UTE MOUNTAIN UTE TRIBE
ENVIRONMENTAL PROGRAMS DEPARTMENT

Exhibit T to December 16, 2011 Comments on DUSA RML Renewal

Re: Reclamation Plan Deficiency List

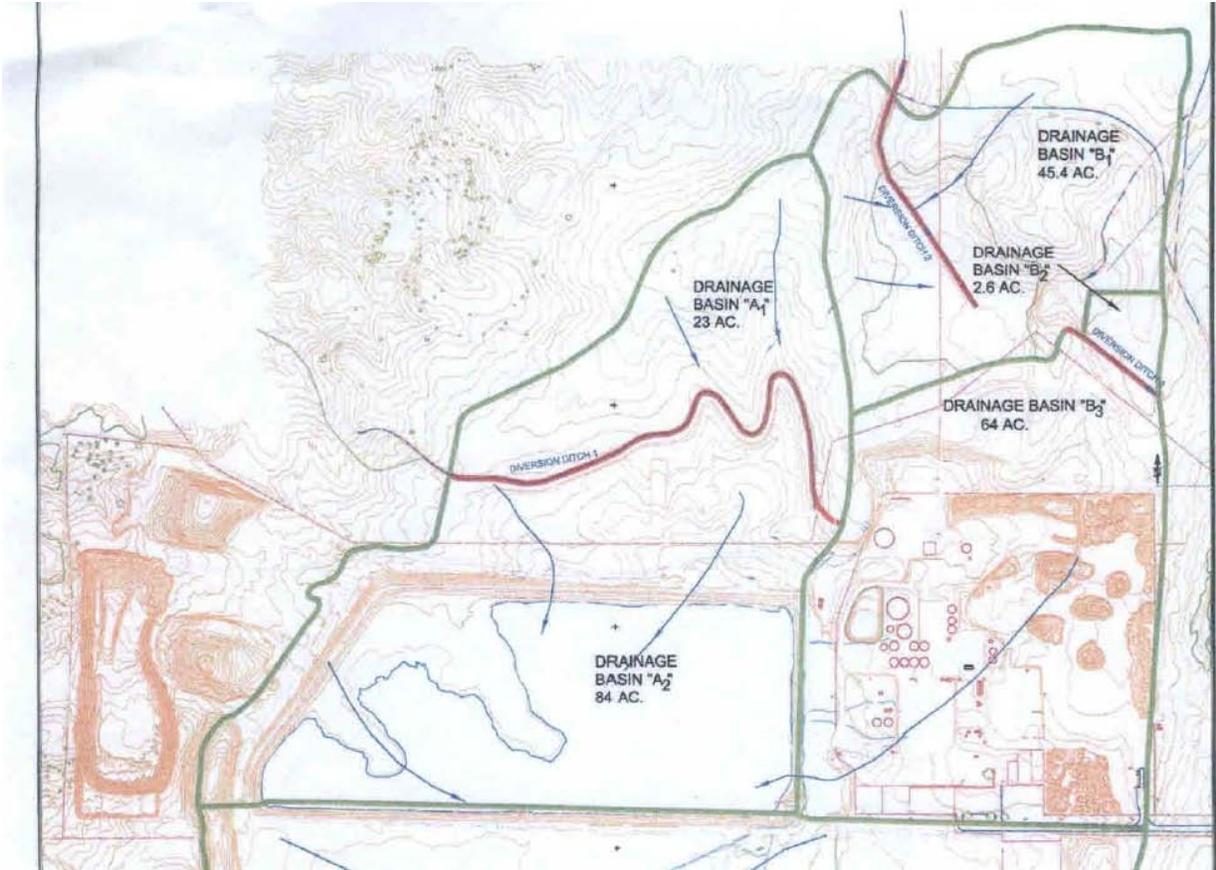
- b. It is not sound planning to build a storm water sediment retention basin against the disposal cell as proposed in Section 1.3.e of Attachment A. It is industry standard to keep water from accumulating on disposed of radioactive materials. The proposed sediment basin has an area of approximately 40 acres with a flat bottom against the debris disposal (cell) area. The storage of accumulated storm water is likely to seep through the contacted cap materials and into the proposed disposal cell area. [White Mesa Mill Tailings Reclamation, Sediment Basin Design, sheet REC-3, MWH, 09/2011]

Drainage patterns from Storm Water Management Best Practices Plan, Figure 2:

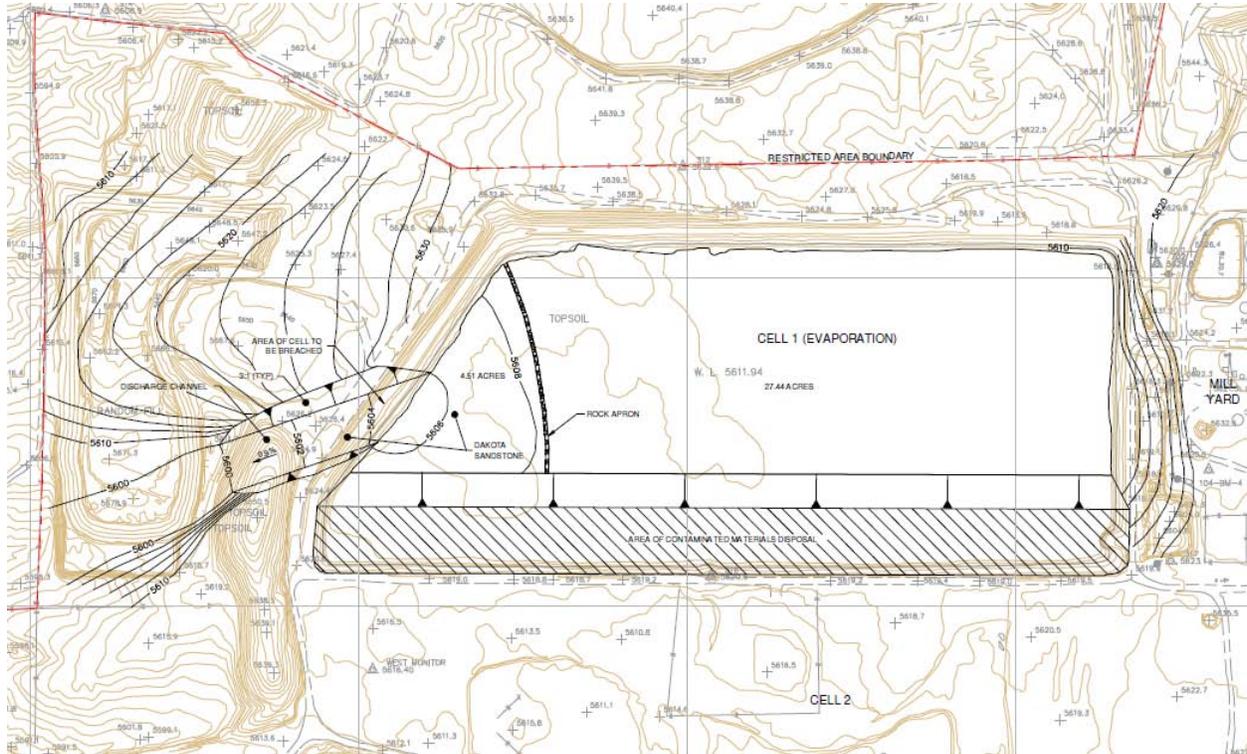
2. The Storm Water Discharge Channel West of Cell 1 Violates the Storm Water Management Plan and Risks Contaminating Westwater Creek with Radioactive Material from the Mill Yard.
 - a. The Reclamation Plan indicates that storm water from within the mill area will drain out the drainage ditch from the sediment basin west towards Westwater Creek once the Cell 1 contents, liner and contaminated soil from beneath the liner have been removed. The Plan also indicates that such drainage will occur prior to reclamation of the mill, which means that the water washed towards Westwater Creek could be contaminated with Radioactive Material and other hazardous waste from the Mill Yard that would continue to drain into the Cell 1 footprint

area. This portion of the Reclamation Plan is not compliant with the storm water management plan, which is a component of the license that DUSA must comply with during reclamation. Accordingly, DUSA cannot comply with the license and also discharge storm water in this manner.

NOTE DRAINAGE FROM MILL AREA INTO CELL 1.
